From: Scherer, Thomas [Thomas.Scherer@siemens.com]
Sent: Friday, 10 October 2008 10:39 AM
To: Ruth Brown
Subject: Kogan Creek ash disposal area information DA IPDE00173405A11

Initial Ash Area Runoff Storage Volume

From: Scherer, Thomas [Thomas.Scherer@siemens.com]
Sent: Friday, 31 October 2008 11:03 AM
To: Ruth Brown
Subject: Marker at ash pond

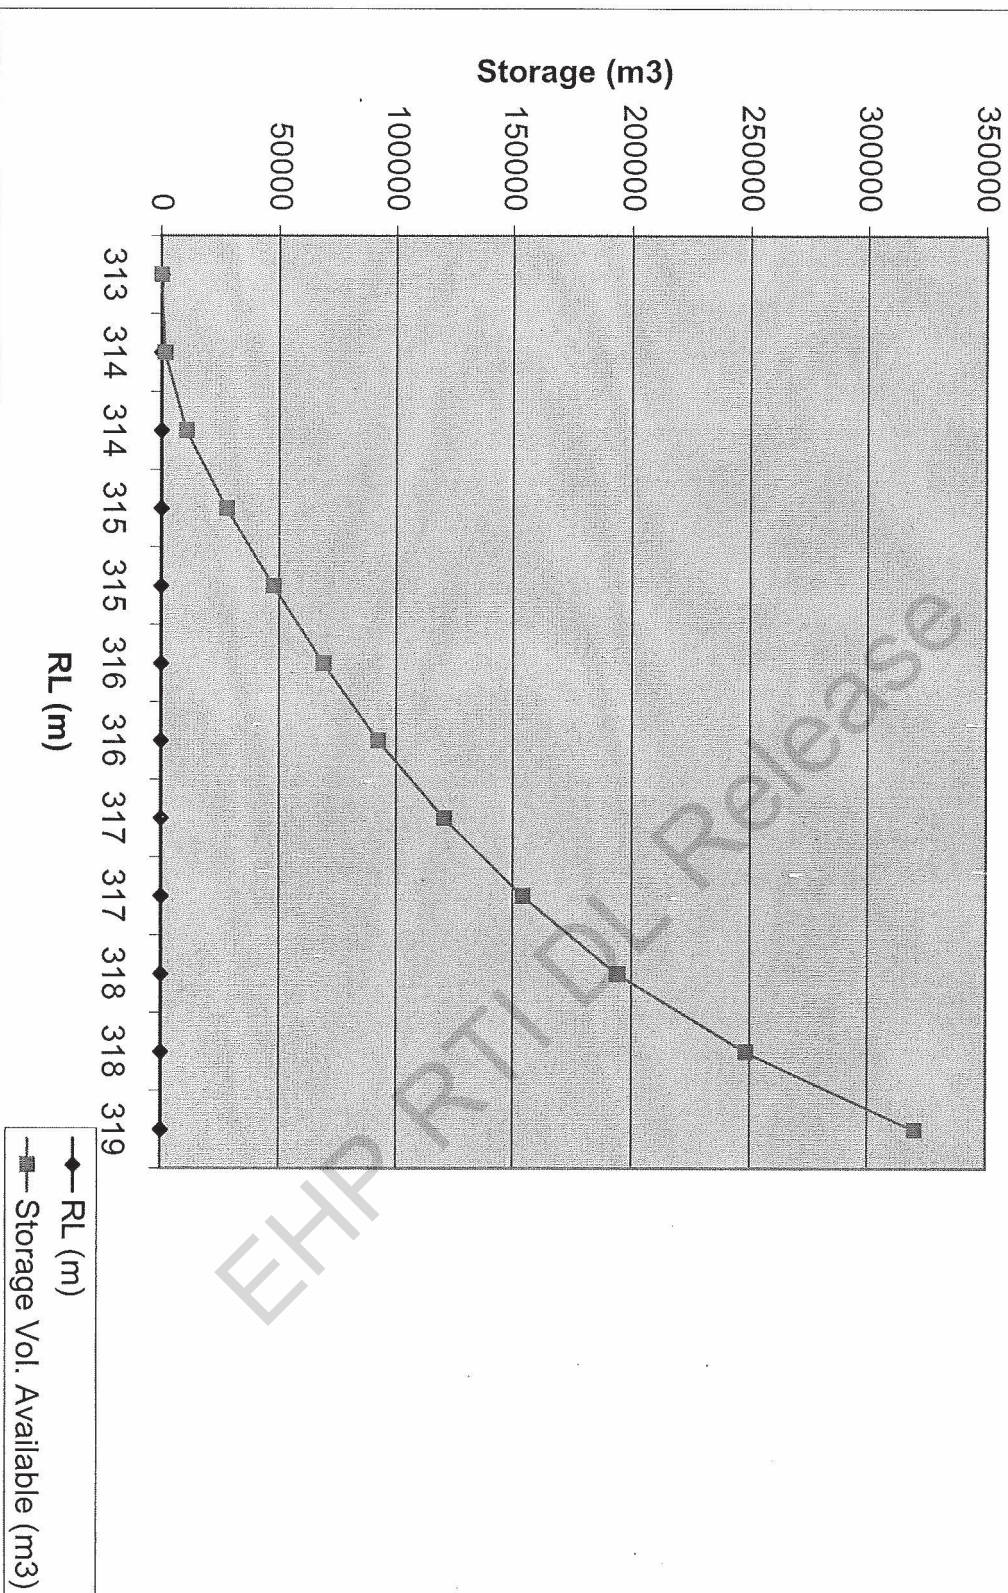
I have attached a few pictures which I took earlier this week. Pictures 1 and 2 show you the water level in the storage area (view from the centre west and east. As you can see the excavated part is almost full and has reached its top in the southeast corner where started fill the low point next to the dam in that very spot. The next three pictures show you the northern section of the ash area where we have filled the north-eastern pocket and you can see the established slope pretty well on these pictures. The last picture shows you the flowing slurry from the outlet which has been in service for 2-3 days (continuous discharge). The picture was taken from around 50m away.

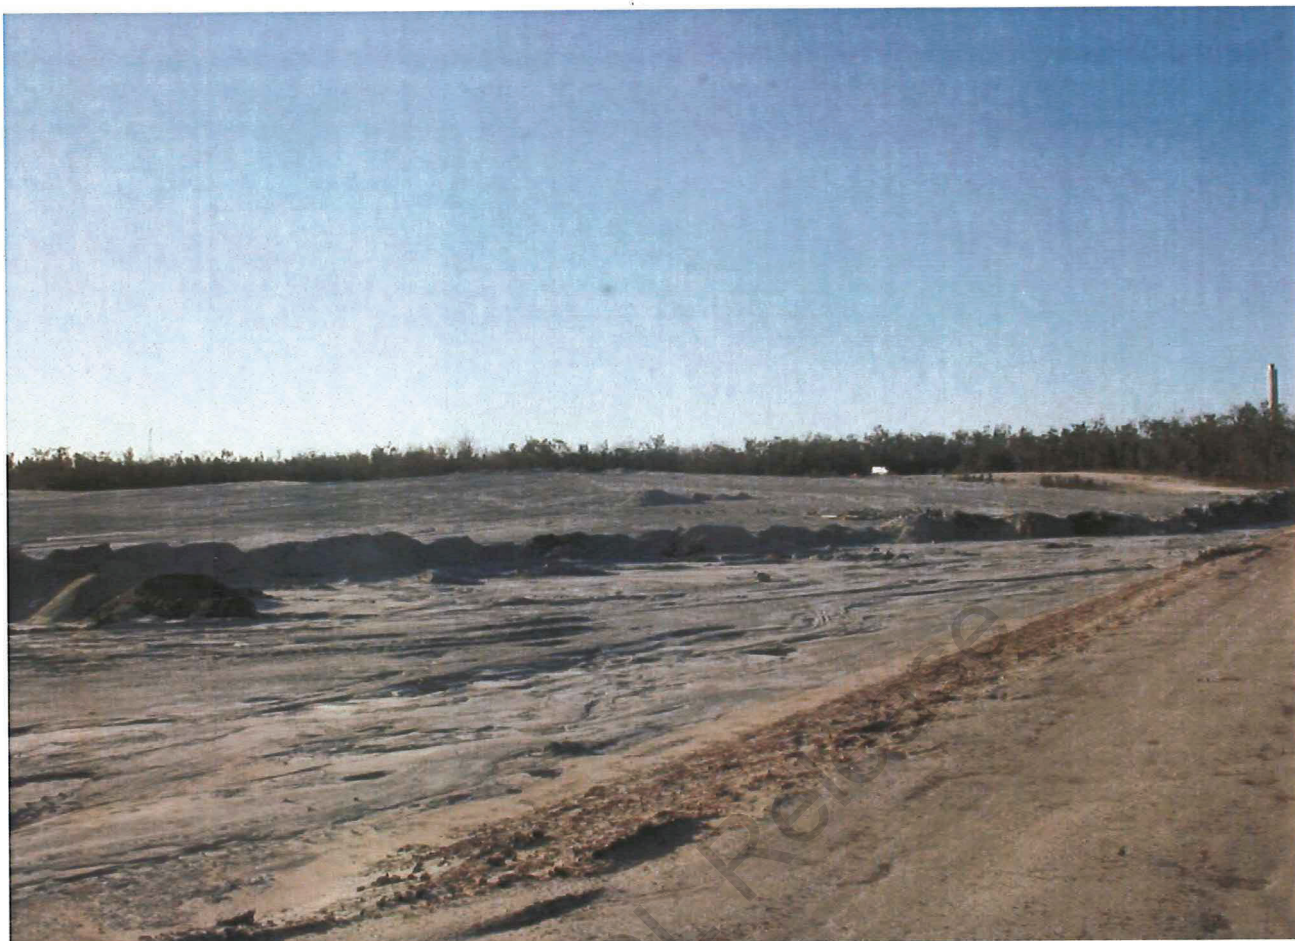
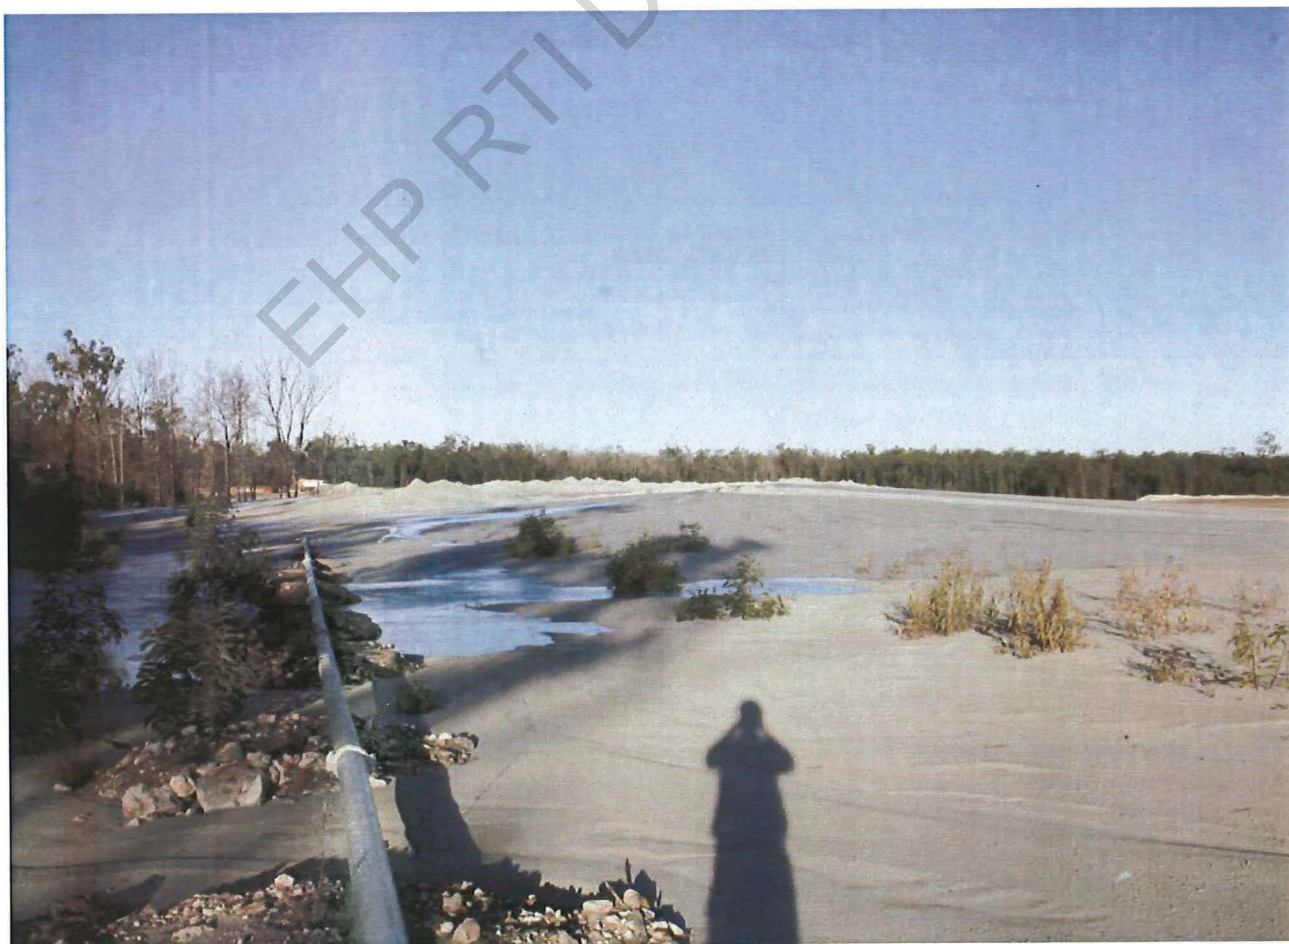
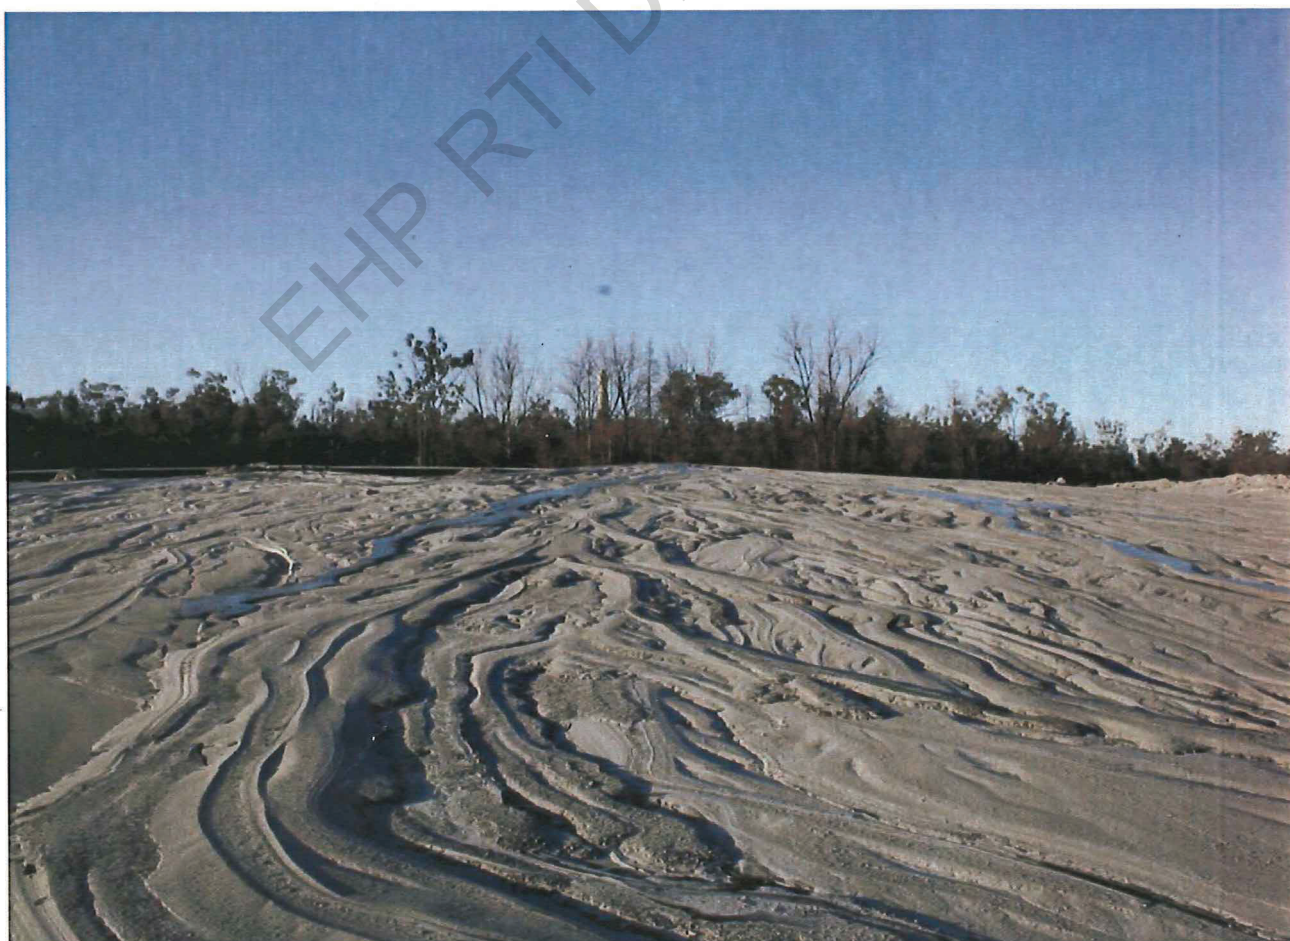
Everything is working fine but we have the issue that we still have water in the Design Storage Allowance. We will not be able to remove the water to provide the full capacity as of Nov 1. The table below shows the capacity over the level up to the spillway height. At the moment we have about 120ML of water still sitting in this area. This is about 35% of the required capacity. *120,000 m³* *capacity of 315 ML*
